#### REMARKS

Selvidge et al. -09/539,463Response to 6/22/04 Office Action

U.S. Serial No.: 09/539,463 Atty. Dkt. No.: 003921.00023 Inventor: Charles W. SELVIDGE, et al. Title: NON-SYNCHRONIZED MULTIPLEX DATA TRANSPORT ACROSS SYNCHRONOUS SYSTEMS

ANNOTATED SHEET SHOWING CHANGES

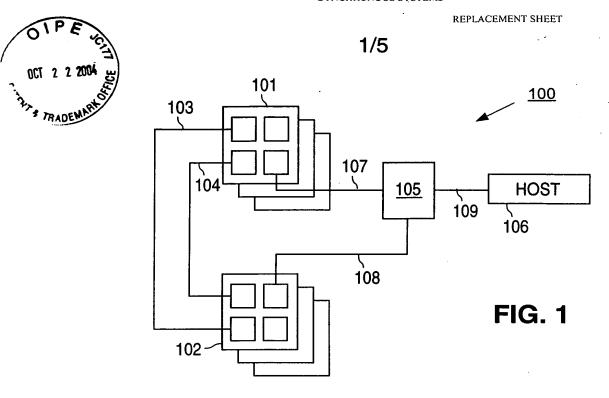
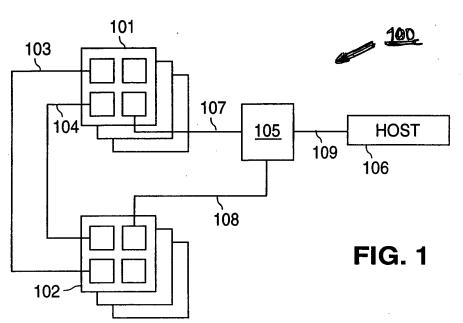
The drawings are objected to for not including a reference to the emulation system 100 as disclosed in the specification. Applicants request that Figure 1 be amended as shown in the attached Appendix to refer to element 100. No new matter is added.
